Access Compliance Report

Public Rights-of-Way

(Curb Ramps)

Intersection ID: 14617	Main Street: BALTIMORE_AV	Cross Street: REMOUNT_RD	Location:	S
ADA ID: F42808B13542	Ramp Type: PerpDiag	Initial Pass/Fail: Fail	Overall Compliance: No	Severity Score: 22.5
Codes/Mitigation Info/Possible Solution		Field Measurements/Component Compliance

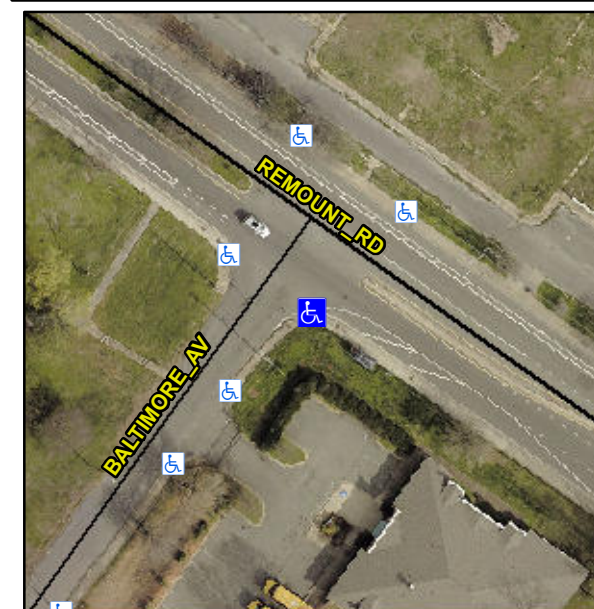
Not Found, R304.5.1, R304.2.2, R304.5.3

Compliance	Description	Data	Compliance	Description	Data
N/A	Ramp Length (in)	60.0	No	Ramp Slope (%)	8.8
No	Ramp Width (in)	37.0	No	Ramp XSlope (%)	3.2
N/A	Flare Type LT	N/A	N/A	Flare Type RT	N/A
N/A	Flare Slope LT (%)	N/A	N/A	Flare Slope RT (%)	N/A
N/A	Flare Traversable LT?	N/A	N/A	Flare Traversable RT?	N/A
N/A	Landing Length (in)	N/A	N/A	DWS Provided?	N/A
N/A	Landing Width (in)	N/A	N/A	DWS Contrast?	N/A
N/A	Landing Slope (%)	N/A	N/A	DWS Length (in)	N/A
N/A	Landing X Slope (%)	N/A	N/A	DWS Full Width?	N/A
N/A	Landing Curb? (Y/N)	N/A	N/A	DWS Offset (in)	N/A
N/A	Shared Landing?	N/A			
N/A	Gutter Ponding?	N/A	N/A	Gutter Slope (%)	N/A
N/A	Gutter Lip Ht (in)	N/A	N/A	Gutter X Slope (%)	N/A
N/A	Painted X Walk1?	No	N/A	Painted X Walk2?	No
	X Walk 1 Direction	To NE		X Walk 2 Direction	To NW
N/A	X Walk 1 Width (in)	N/A	N/A	X Walk 2 Width (in)	N/A
	X Walk 1 Slope (%)	1.7		X Walk 2 Slope (%)	1.5
	X Walk 1 X Slope (%)	1.5		X Walk 2 X Slope (%)	0.6

Remove & Replace Curb Ramp With Two New Directional Ramps or Equivalent.
